Appeal Overview 40 Main

40 Main Street

STAFF'S REASONS FOR DENIAL

FROM PARKING STANDARDS EXHIBIT 'A'

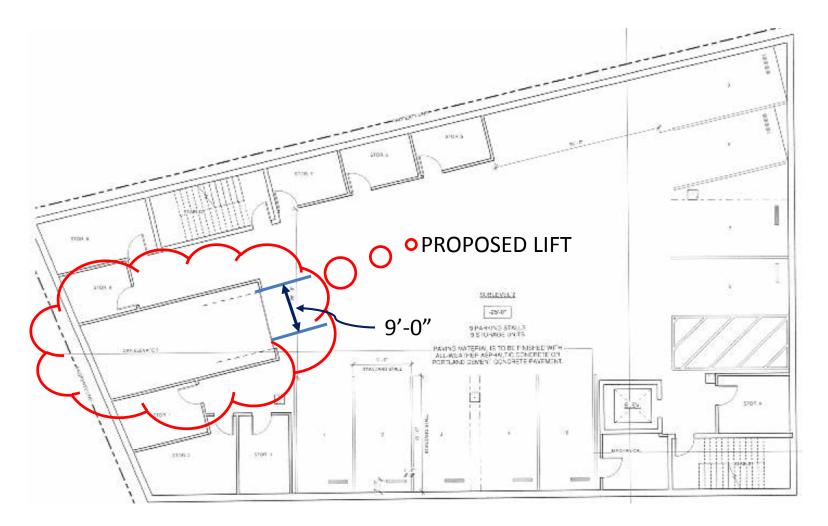
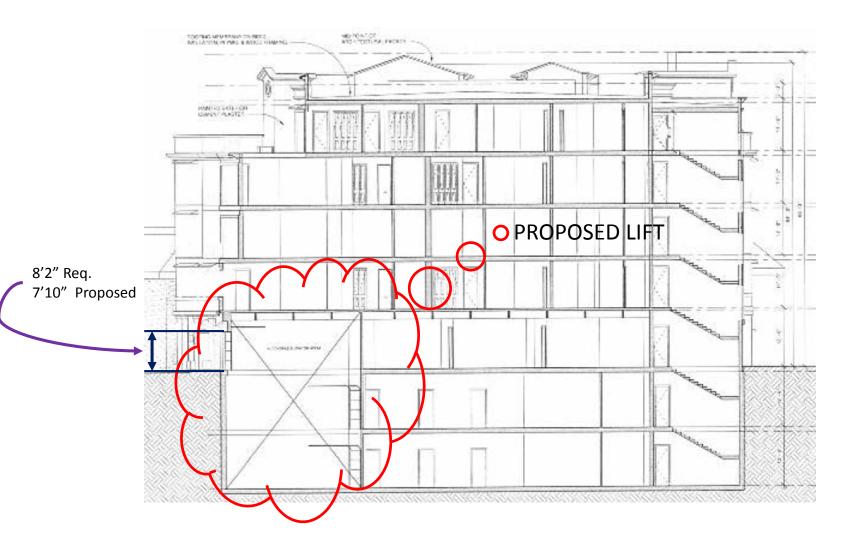
- Municipal Code Section 14.74.200 N., requires that off-street parking areas be in accordance with the minimum standards shown on the drawing labeled "Parking Standards Exhibit A".
- Exhibit A provides no standards or allowances for a vehicle lift system.
- Exhibit A provides detail of standards for ramps providing access/egress to parking
- Width of lift opening is 9', less than required for drive aisles in Exhibit A
- Clearance to lift does not provide vertical clearance of 8'2", CBC section 1109A.4
